LAA/AWA/16/05  
2<sup>nd</sup> November 2015

## Rotax 912 & 914 (Series) Engines

### Engine Temperature Measurement

Fig. 2. Picture showing a post 2013 cylinder assembly designed to measure coolant temperature; note that the sensor faces up.

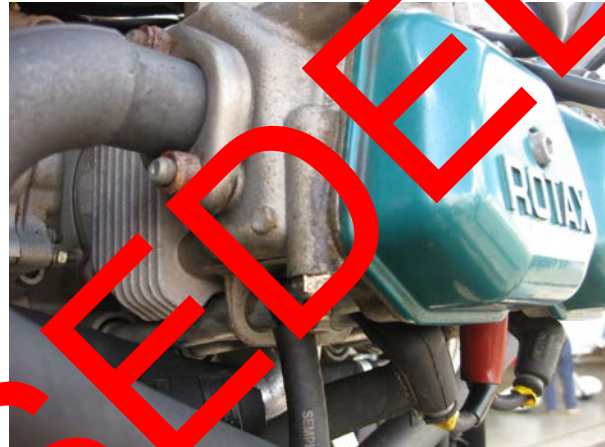
A design change in the cylinder heads of Rotax 912 engines was introduced in March 2013 which meant that the measurement of engine cylinder temperature changed from the measurement of the temperature of aluminium head itself (CHT) to the measurement of the temperature of the water (Coolant Temp.) in the water jacket. Though, in most respects, the temperature gauges and the sensors themselves are very similar, there is a difference in the permissible maximum indicated temperature.
